**Zoning Ordinance Approval
CITY OF AUSTIN
RECOMMENDATION FOR COUNCIL ACTION**

SUBJECT: C814-90-0003.13 - Harris Branch PUD Amendment #13 - Approve second/third readings of an ordinance amending Chapter 25-2 of the Austin City Code by rezoning property locally known as 1375 U.S. Highway 290 East at Proposed State Highway 130 (Harris Branch, Gilleland Creek, Decker Creek Watersheds) from planned unit development (PUD) district zoning to planned unit development (PUD) district zoning to change a condition of zoning. First reading approved on October 27, 2005. Vote: 6-0, Council Member Alvarez off the dais. Applicant: Austin HB Residential Properties (John McCullough). Agent: Minter, Joseph & Thornhill, P.C. (John M. Joseph). City Staff: Sherri Sirwaitis, 974-3057.

ZONING CASE NUMBER: C814-90-0003.13

ZONING CHANGE REVIEW SHEET

Current Approved Harris Branch PUD Land Use Plan

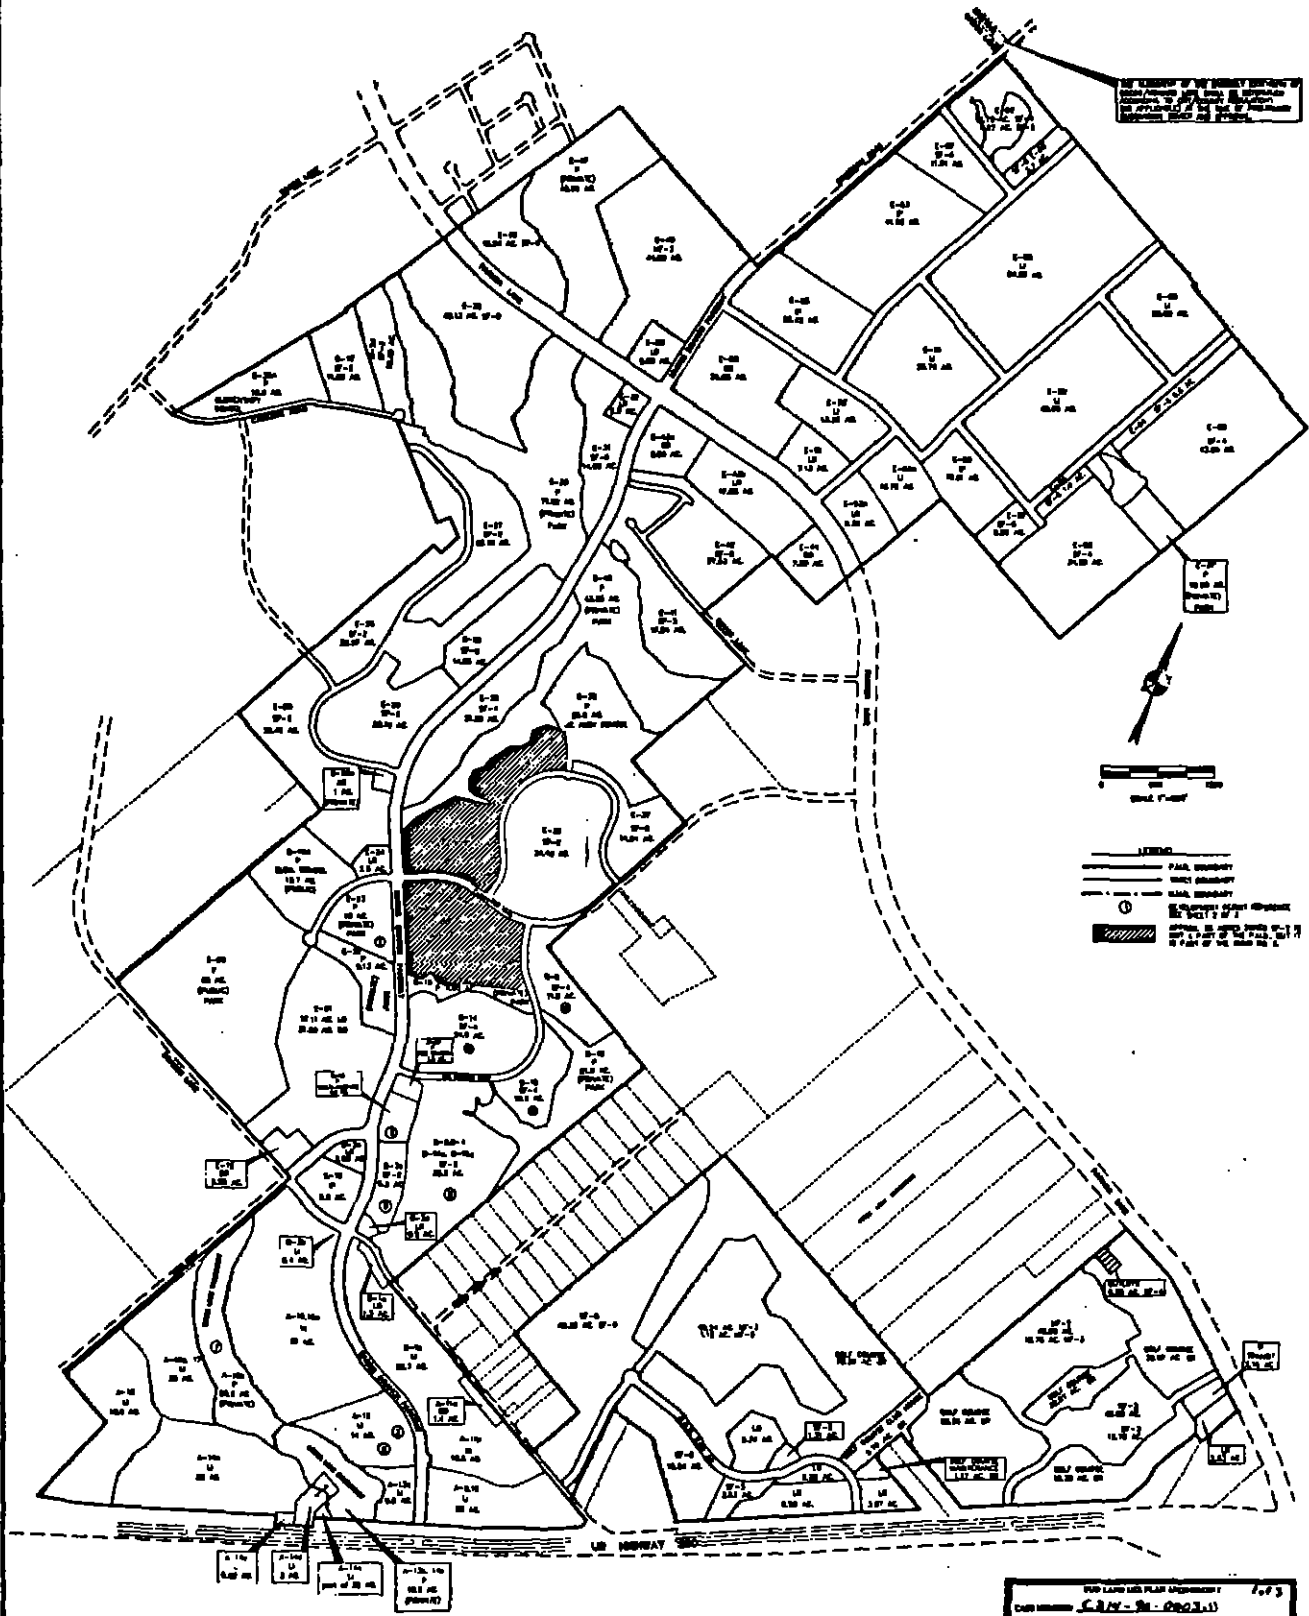
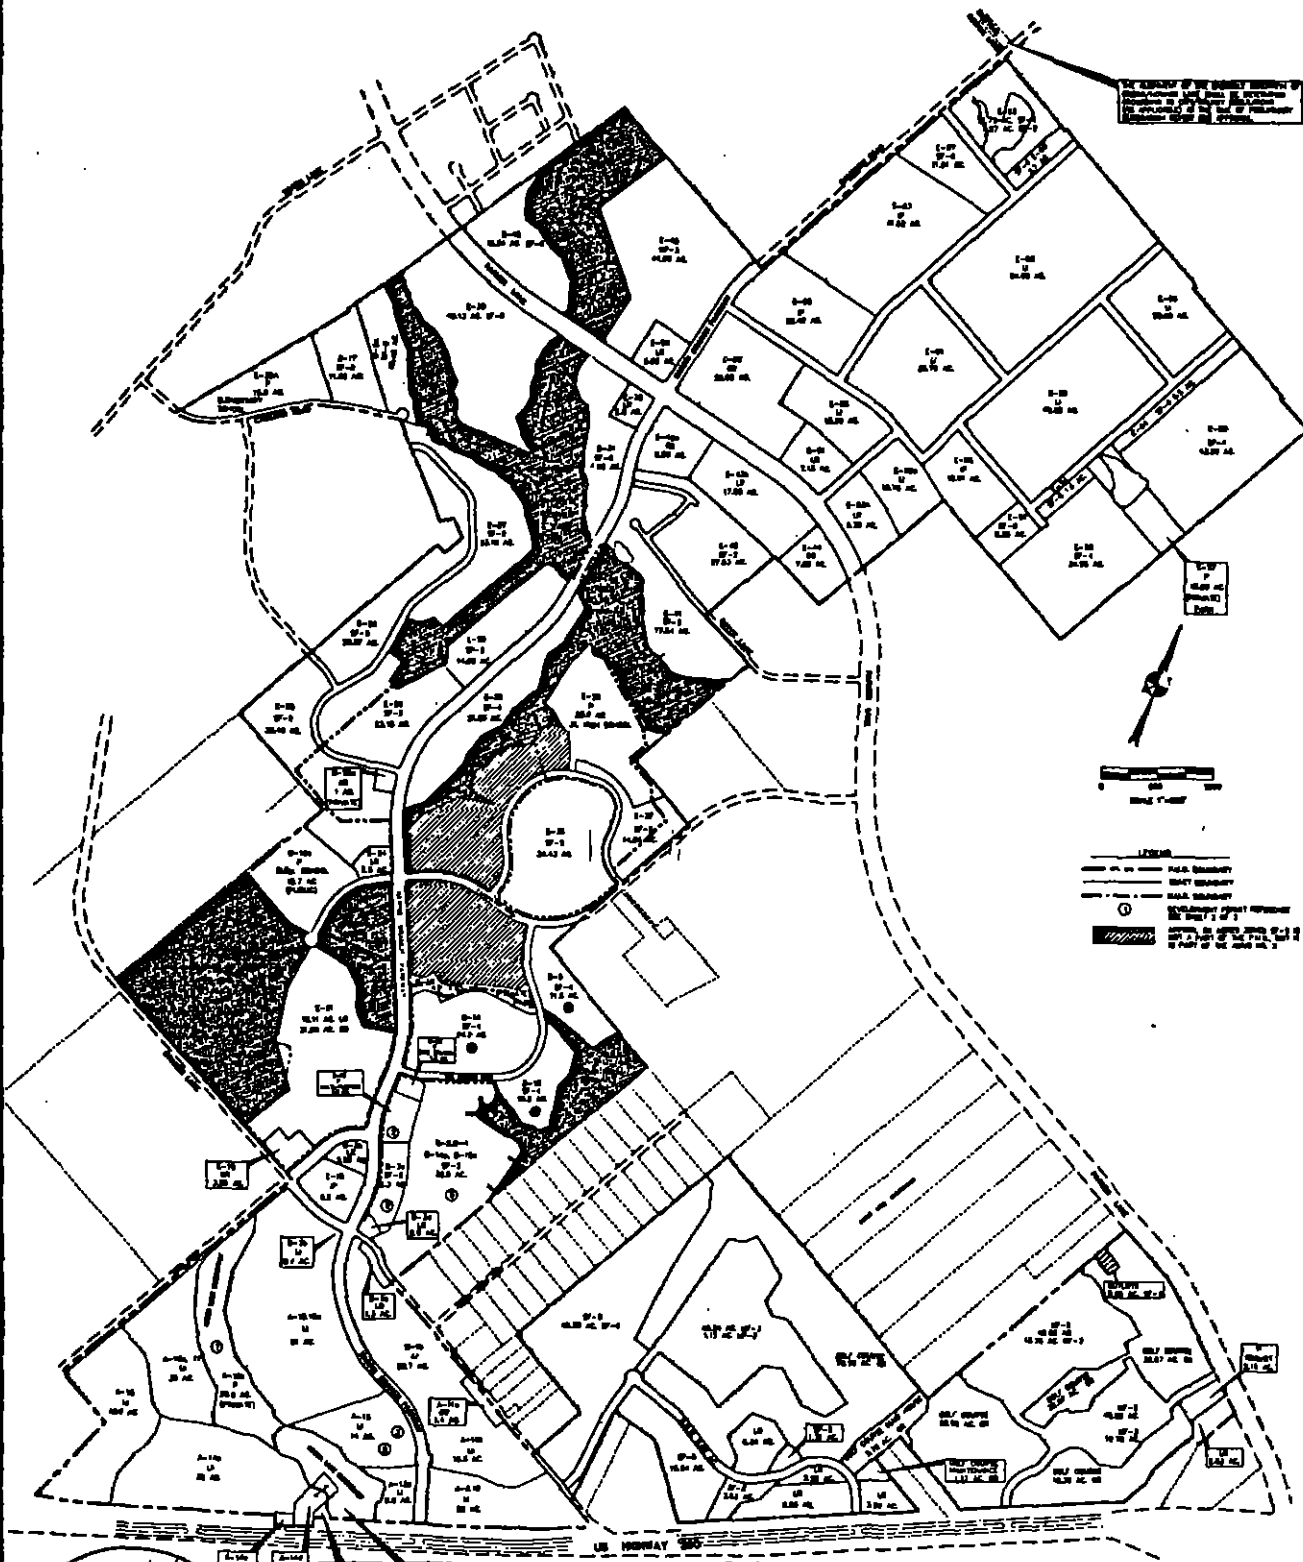
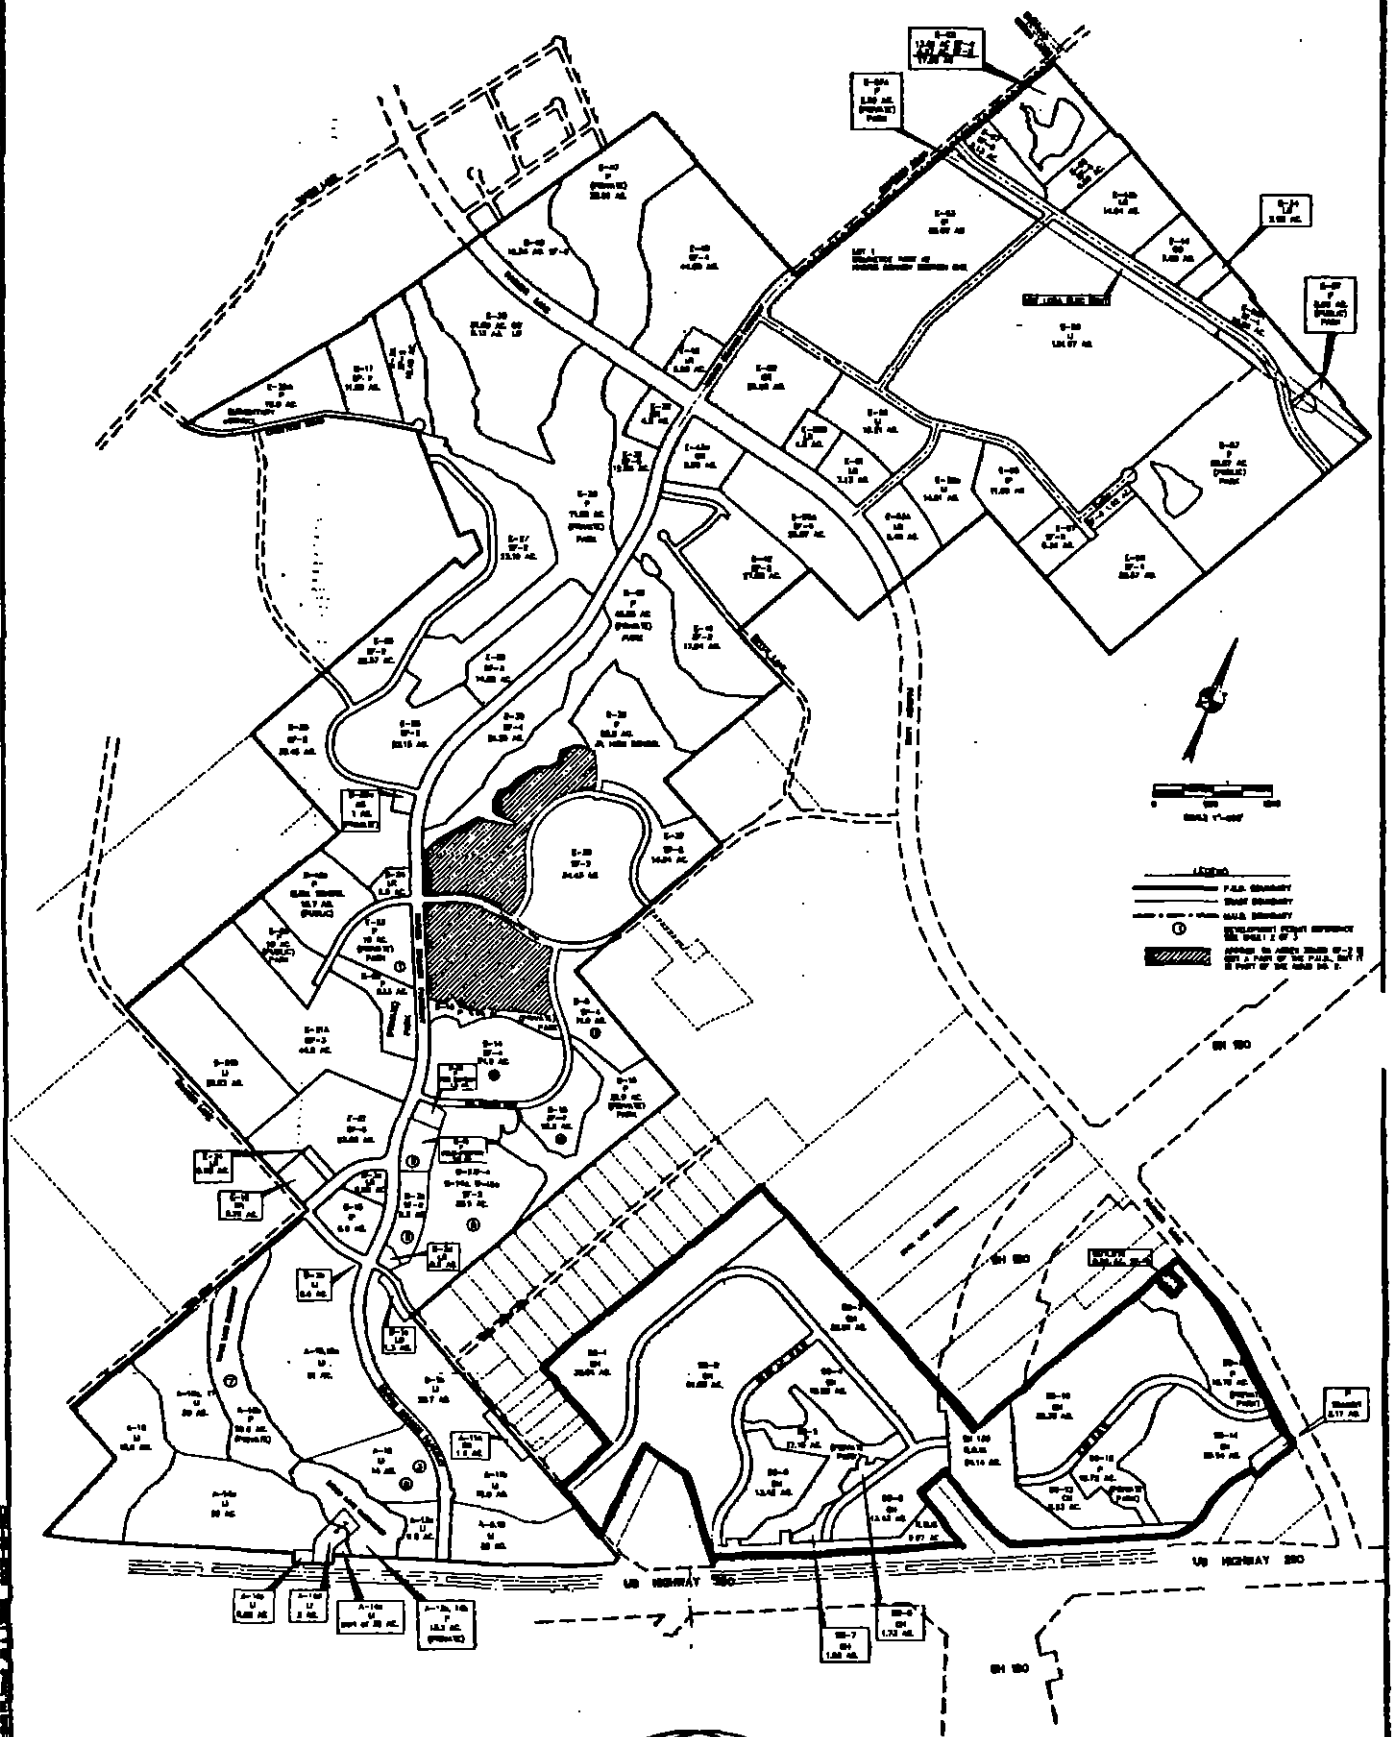
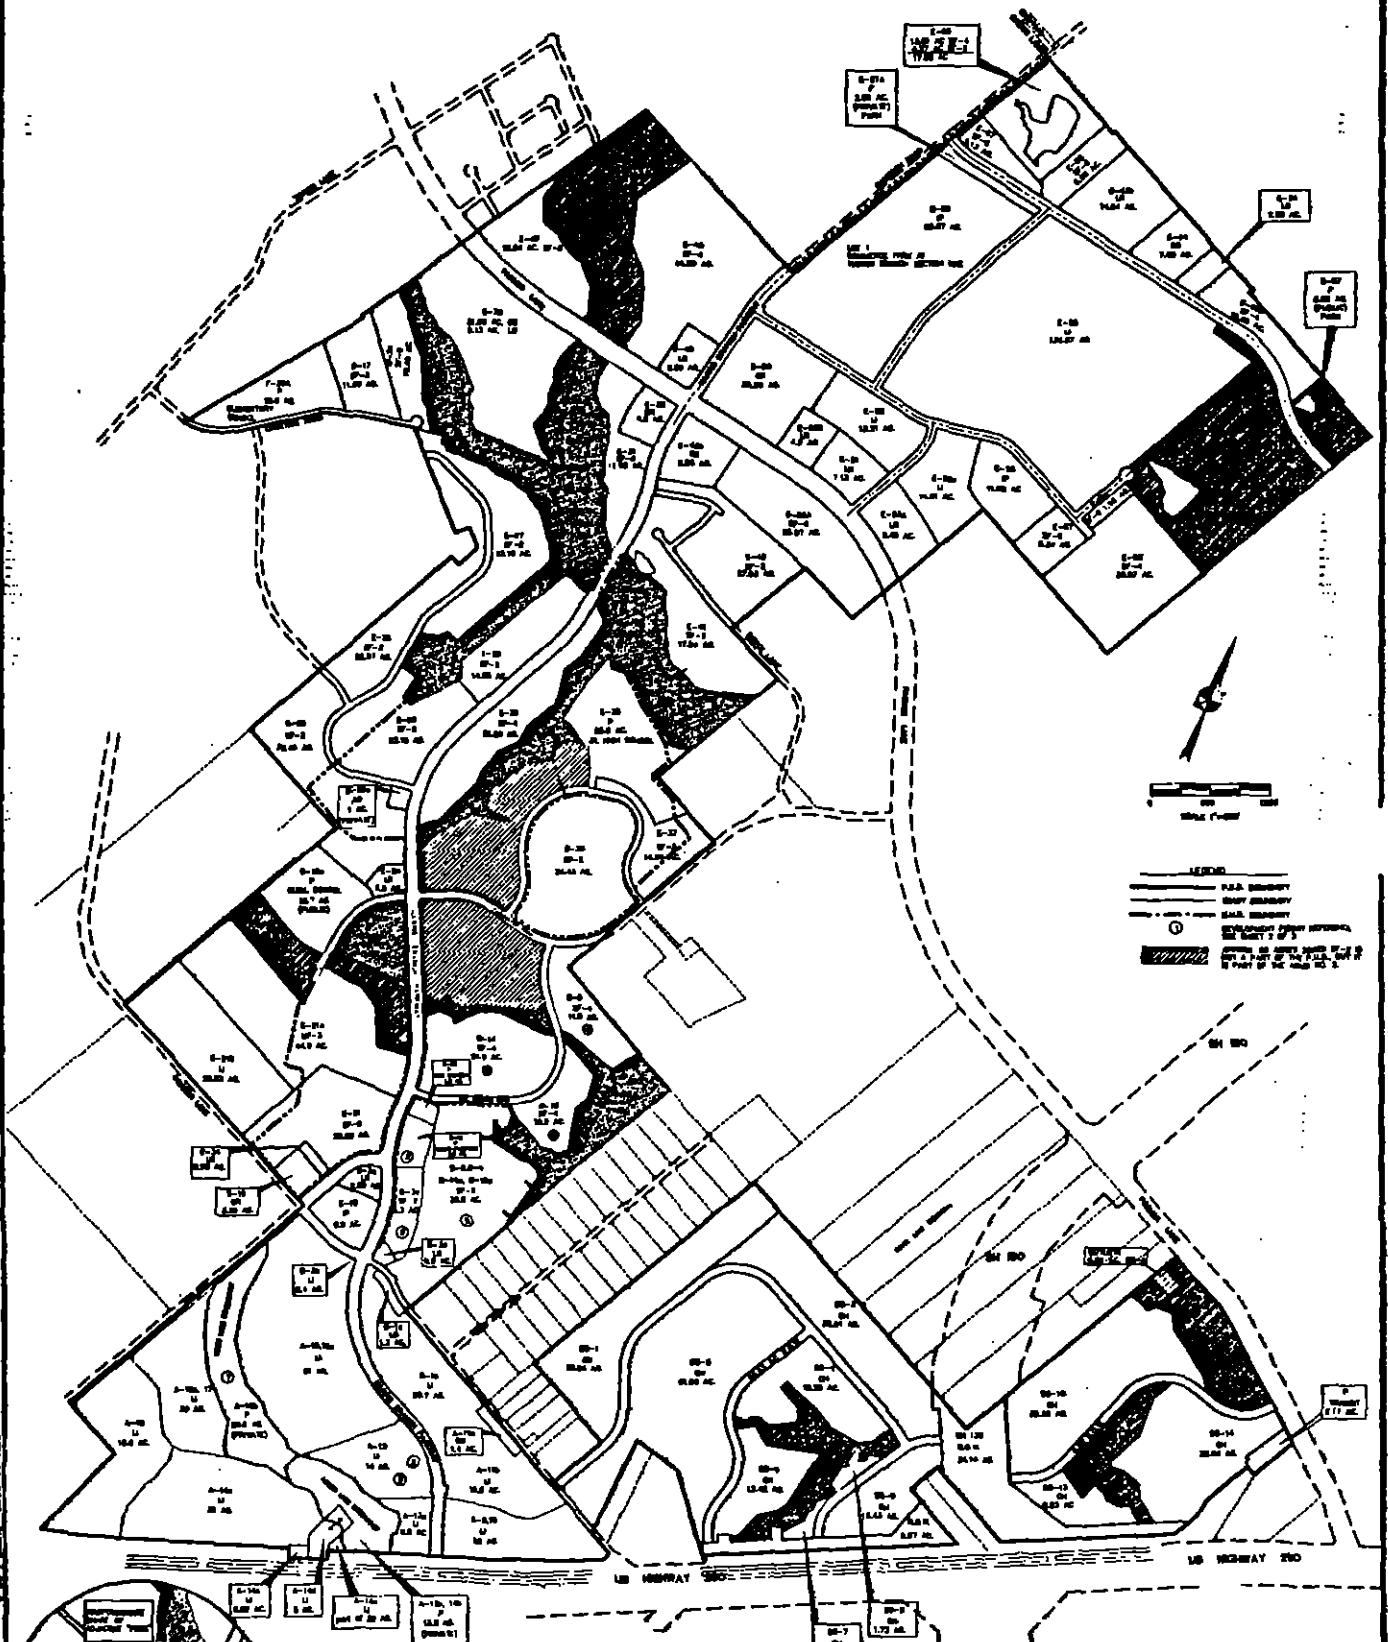
It is difficult to tell on sheet 2 of the PUD plan what has changed, since Revision 13 is with 11 & 12, and the changes were not clouded.

Please redline the approved Harris Branch PUD Land Use Plan to directly show the proposed changes for the PUD. Please redline the PUD Densities Tables - Sheet 2 to display how the proposed revisions to Tracts SG-1 through SG-14 will affect the breakdown of uses and within the PUD. Please provide information concerning the how the proposed land use changes will affect the overall building coverage and impervious cover amounts within the PUD.

ZN-2 The Harris Branch PUD Land Use Plan has a "red line" drawn around the areas subject to this amendment. Attached Please see the revised Harris Branch Density Tables - Sheet 2 showing the effect on building coverage and impervious cover.
